Regional Planning Commission  
Kingston Springs, Tennessee

**9 November, 2023**  
**Meeting Packet**

**Re: Ellersly Subdivision  
Phase 1 Pond Revision - Resubmittal**

## Ellersly Subdivision

## TO OFFSITE STORM - 25 YR

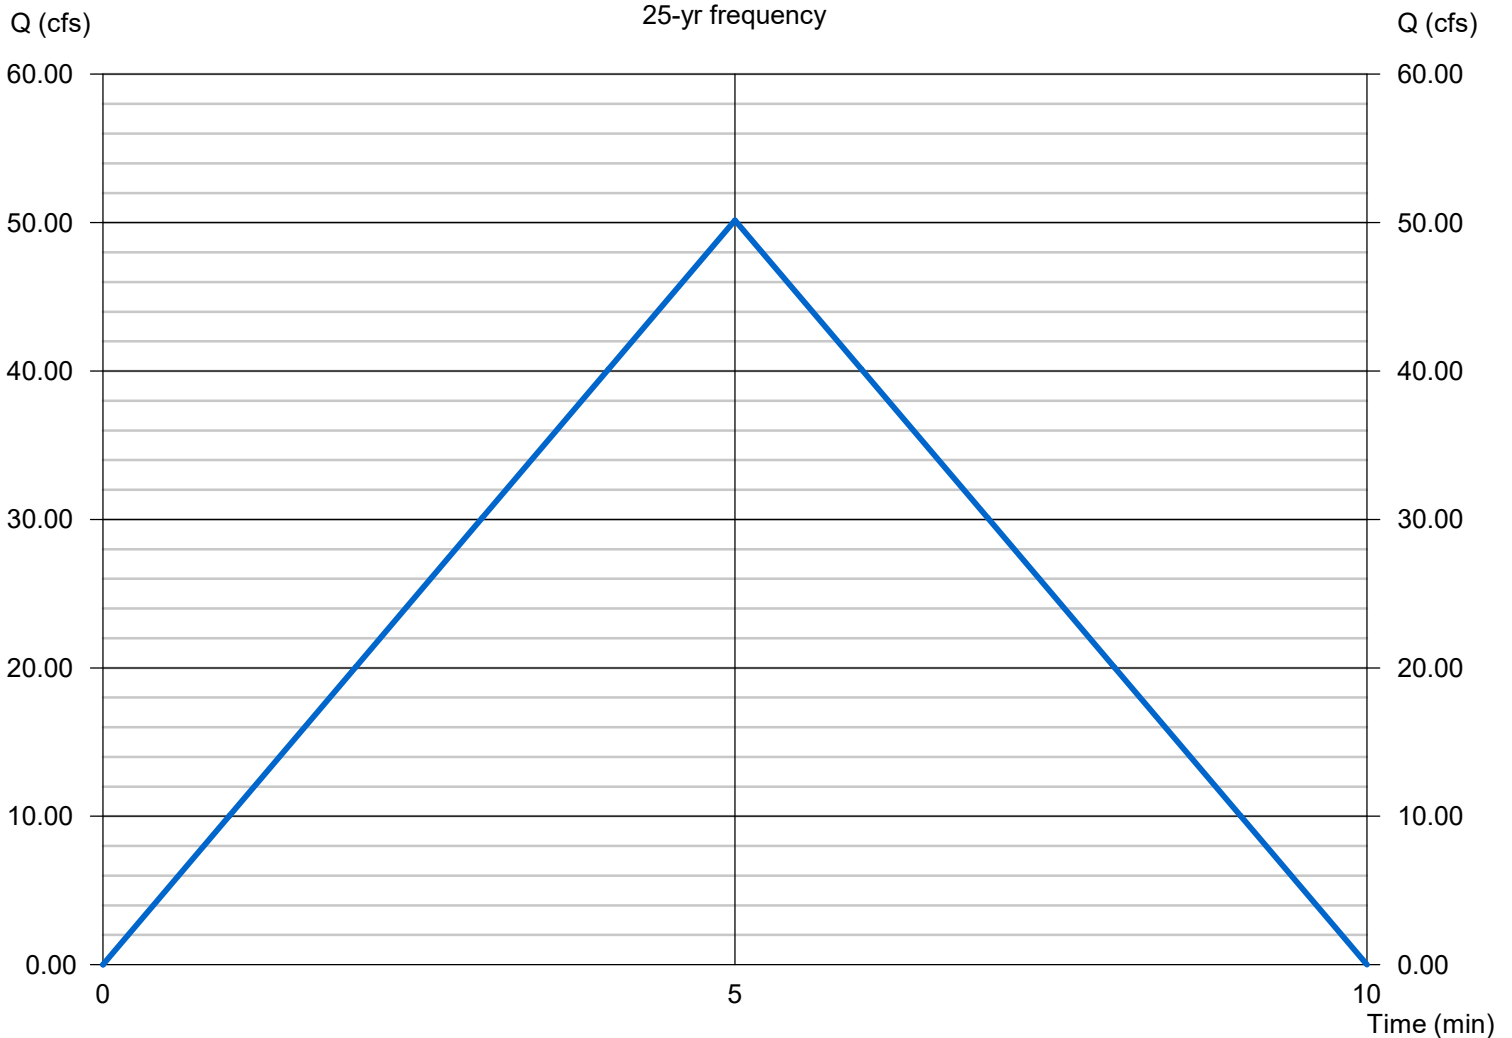
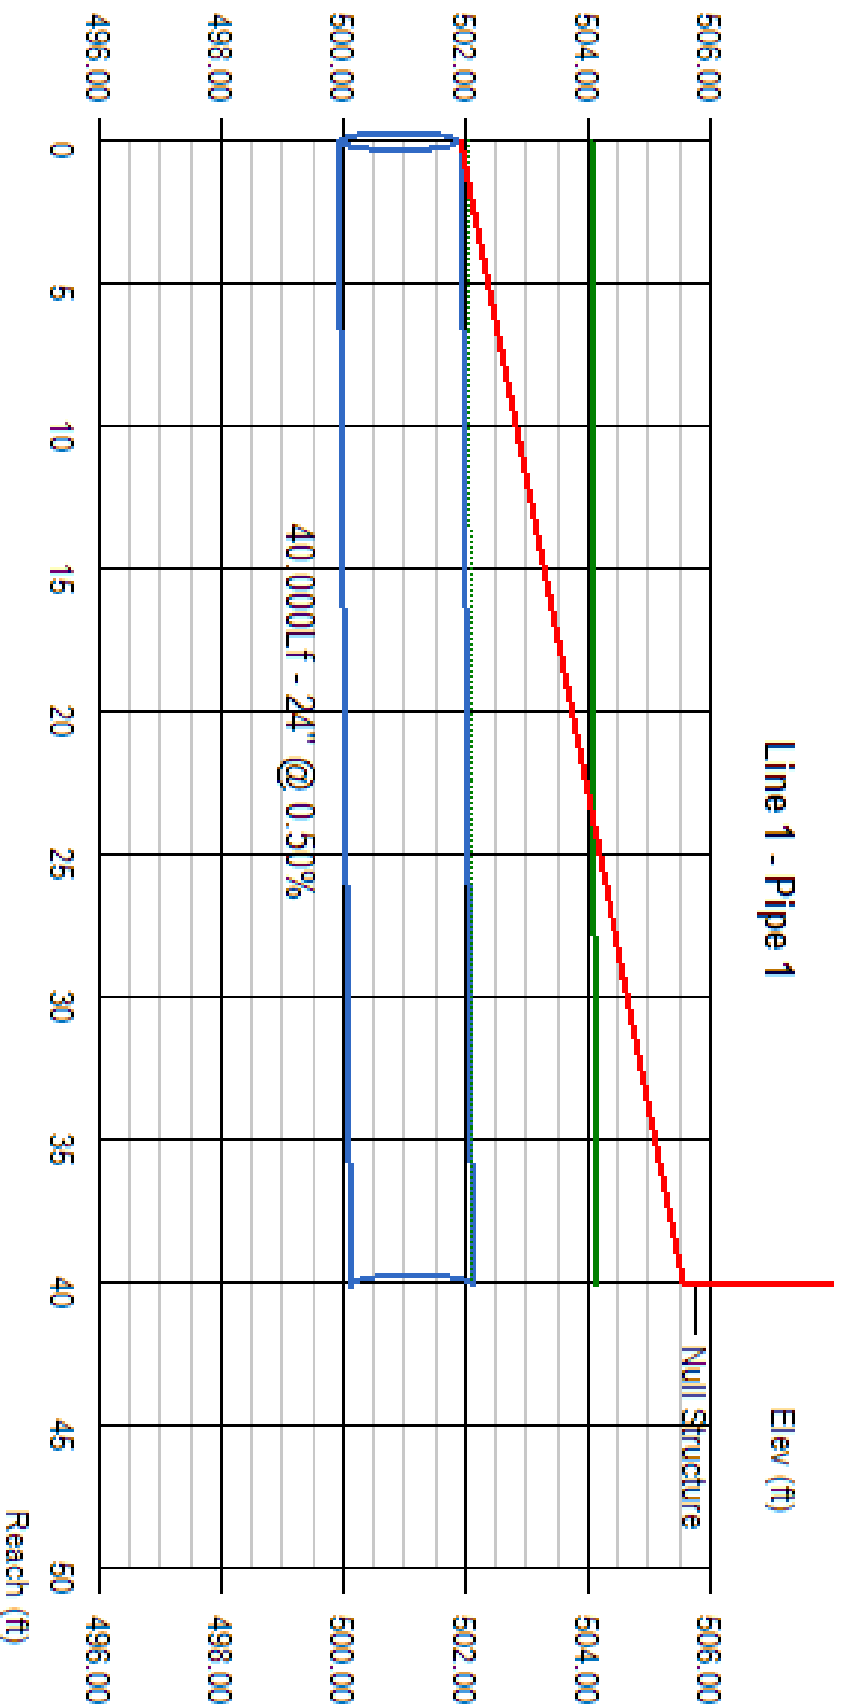
1. Show pipe calculations for pipe under road to 25-year storm  
**Pipe calculations have been added herewith for the existing pipe under W Kingston Spring Road.**

**ROAD ELEVATION: 504'**  
**2 YR HGL: 502.89'**  
**5 YR HGL: 503.82'**  
**10 YR HGL: 504.50'**  
**25 YR HGL: 505.56'**

**ELLERSLY  
 SUBDIVISION  
 PHASE 1**  
 0 ELLERSLY WAY,  
 KINGSTON SPRINGS,  
 CHEATHAM COUNTY,  
 TENNESSEE

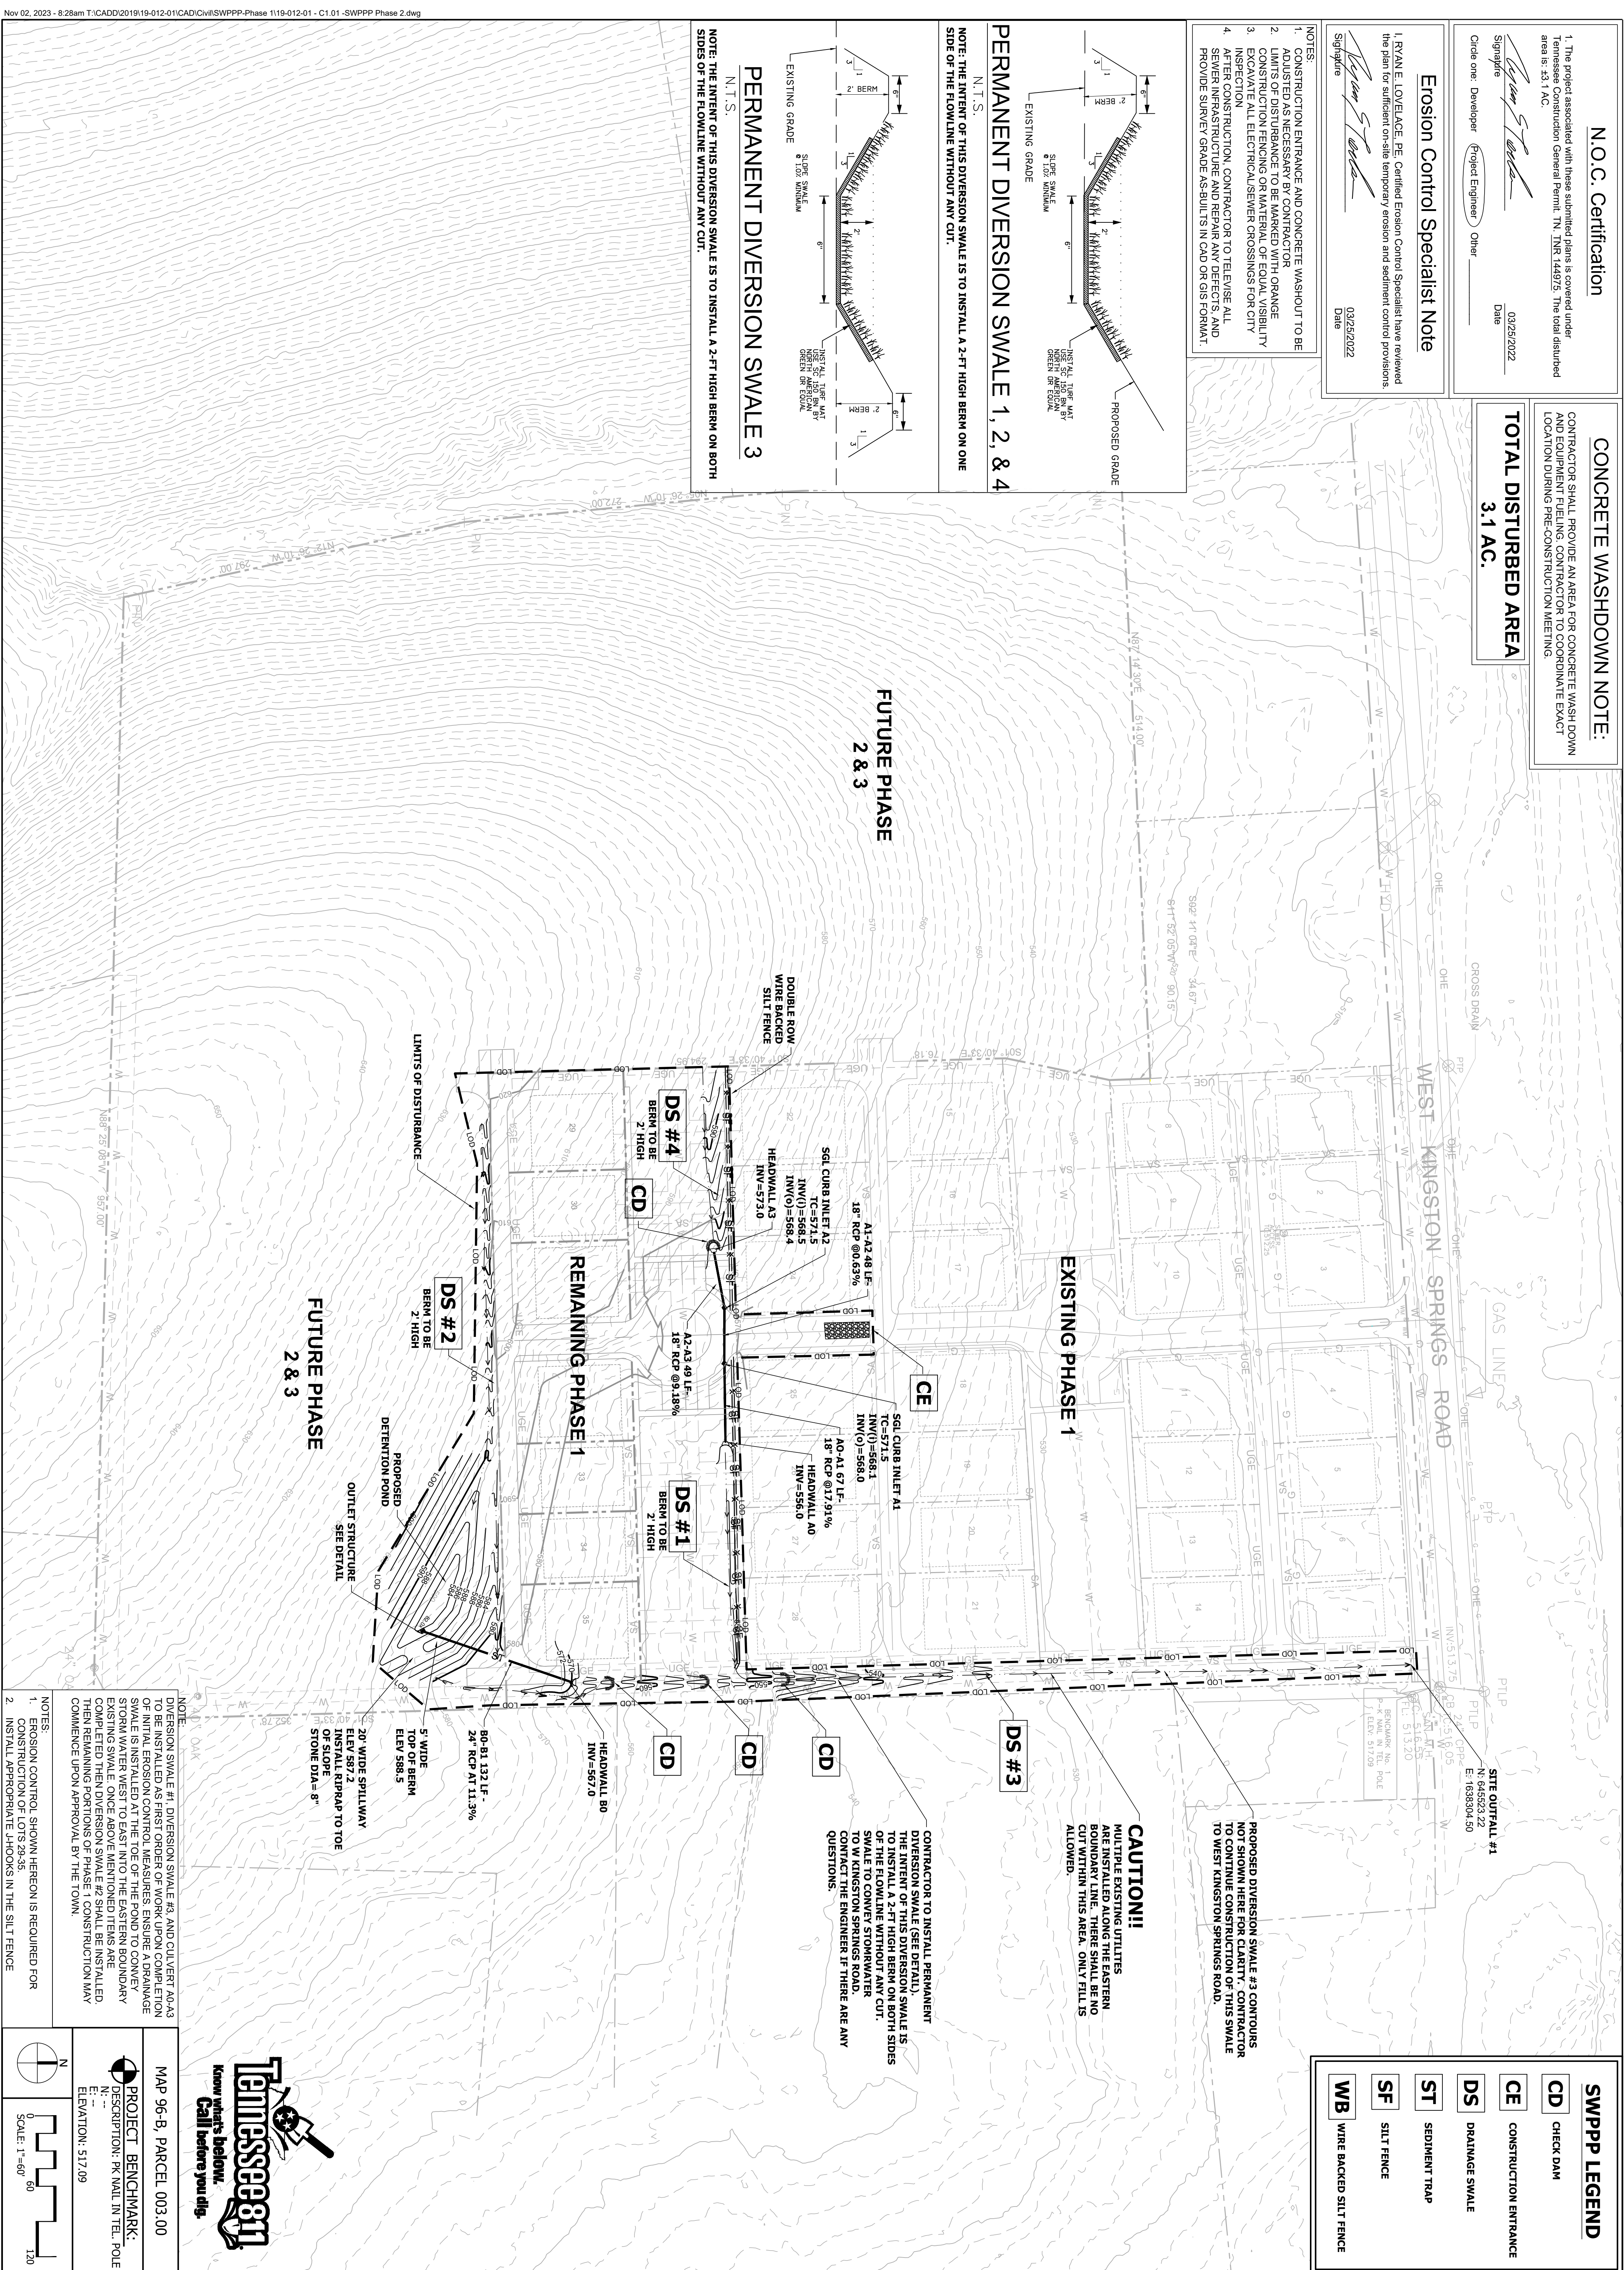
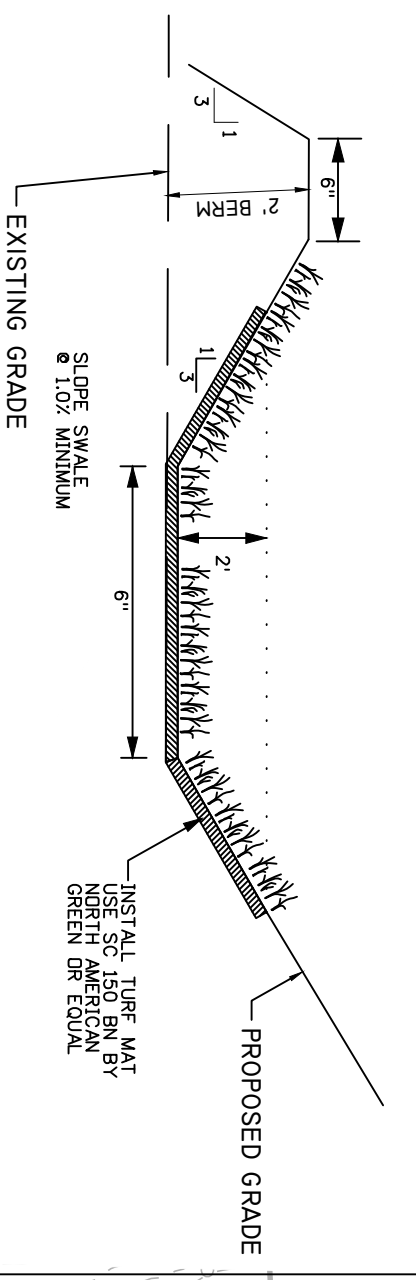
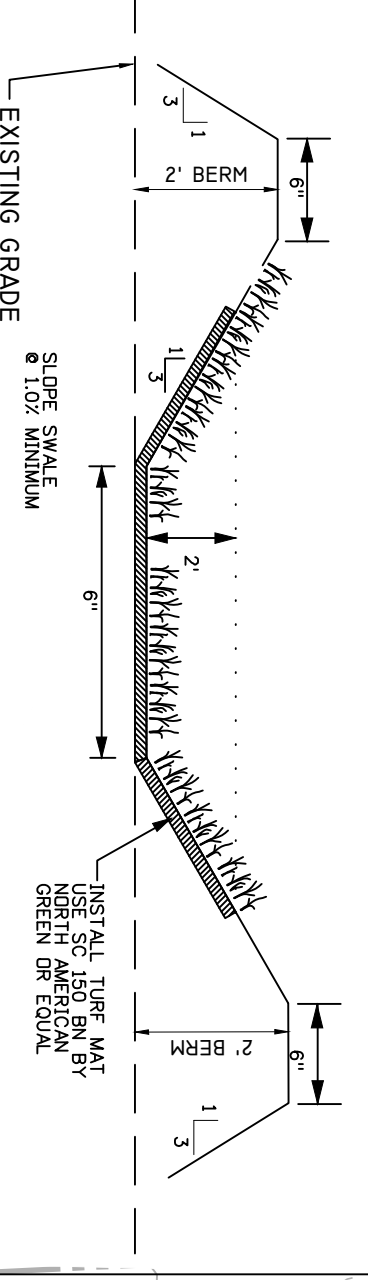
4. Excavate all electrical/sewer crossings for city inspection  
**Note has been added. See sheet C1.01.**
5. After construction, contractor to televise all sewer infrastructure(mains, manholes, clean-outs, and laterals), and repair any defects, and provide survey grade as-builts of the sewer system in CAD or GIS format.

**Note has been added, see sheet C1.01.**
6. Provide a summary table summarizing the pre-and post development peak flows for each event.  
**A summary table has been added to drainage report.**
